Re: Turkey Point Units 3 and 4
Docket Nos. 50-250 and 50-251
Proposed License Amendments
Removal of Site Area and Plant Area Maps from Technical Specifications

**PROPOSED LICENSE AMENDMENT FOR
CHANGE TO TECHNICAL SPECIFICATIONS**

FIGURE 5.1-1 SITE AREA MAP

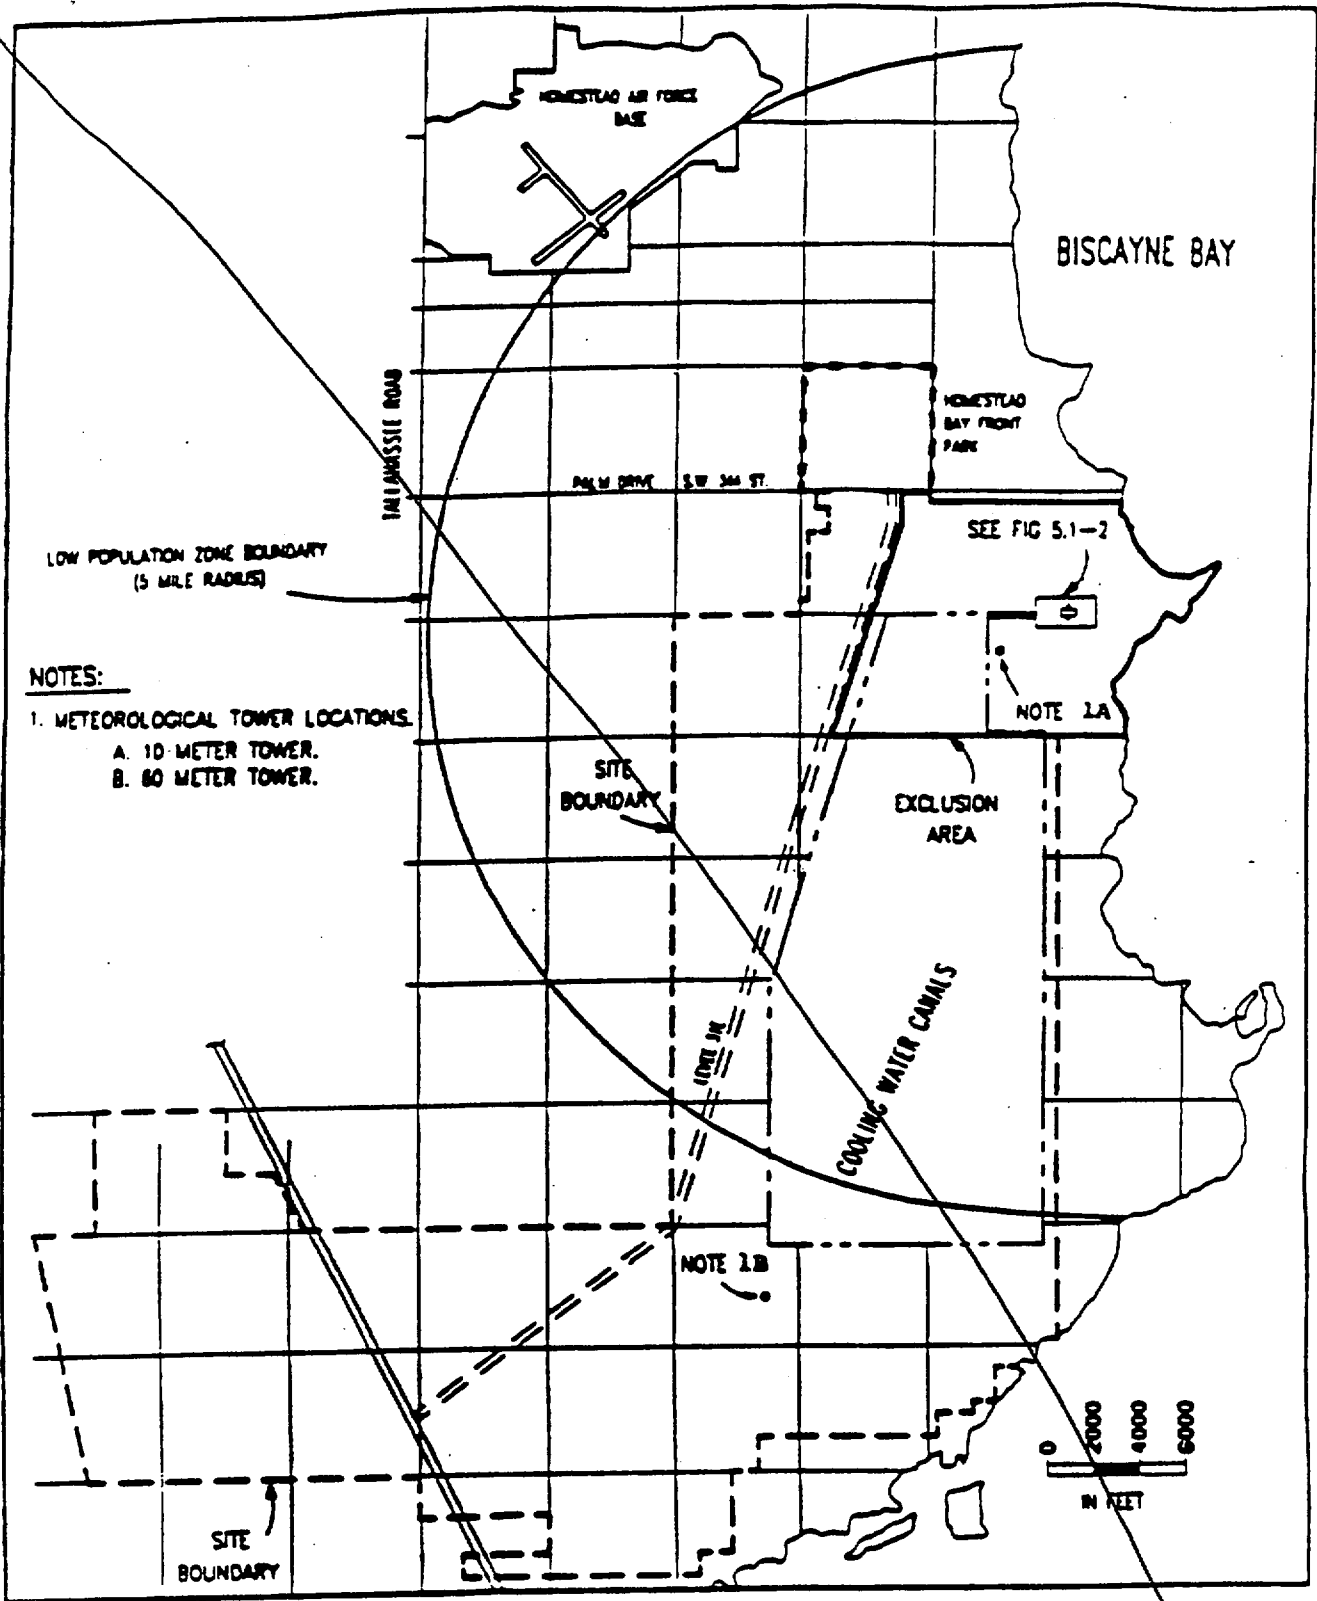
4. Revise TS 5.0, Design Features, to delete Figure 5.1-1, Site Area Map, and Figure 5.1-1, Plant Area Map.

4. This change would make Turkey Point's TS conform to the ISTS. Section 4.0, Design Features of ISTS does not include equivalent sections to Turkey Point TS Figure 5.1-1 and 5.1-2. Additionally, the Site Area Map is located in Section 2.2 of the Turkey Point UFSAR and the Plant Area Map is located in Section 1.0 of the Turkey Point ODCM. 10 CFR §50.36 does not require these sections to be contained in the Technical Specifications.

delete page

~~FIGURE 5.1-2 PLANT AREA MAP~~

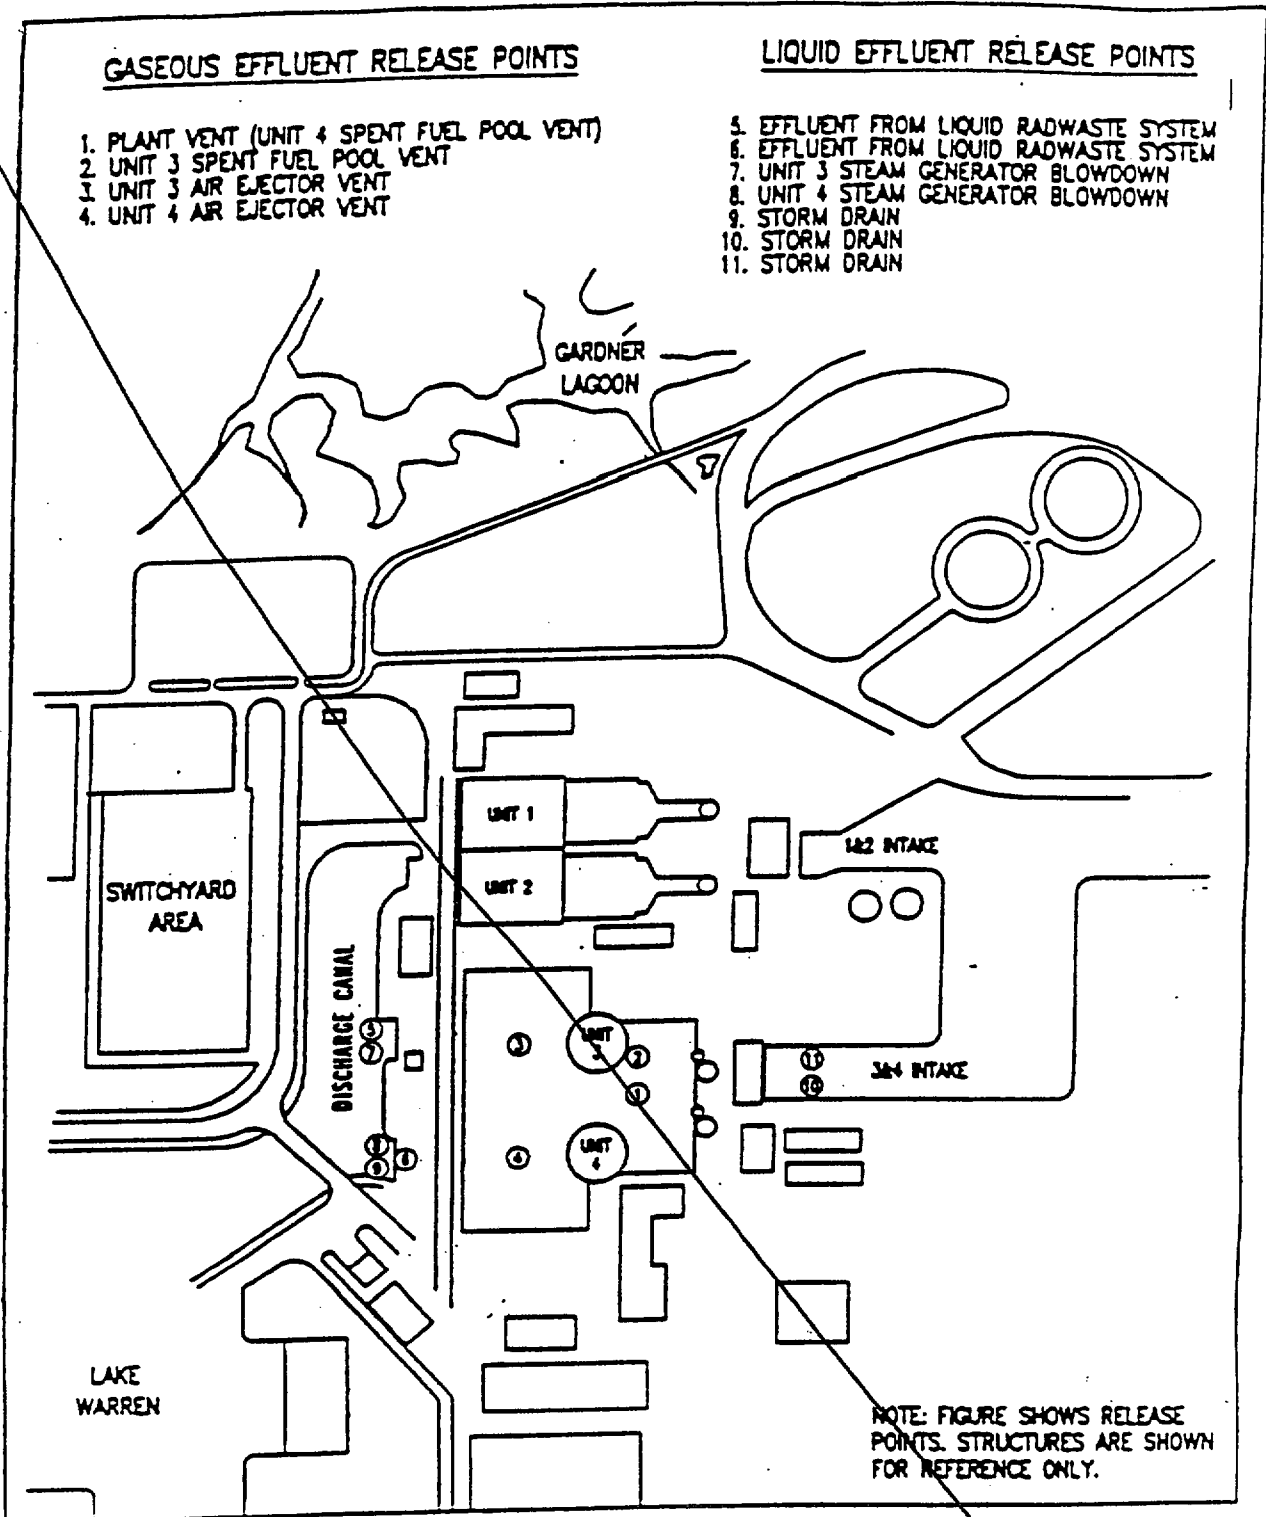
delete page
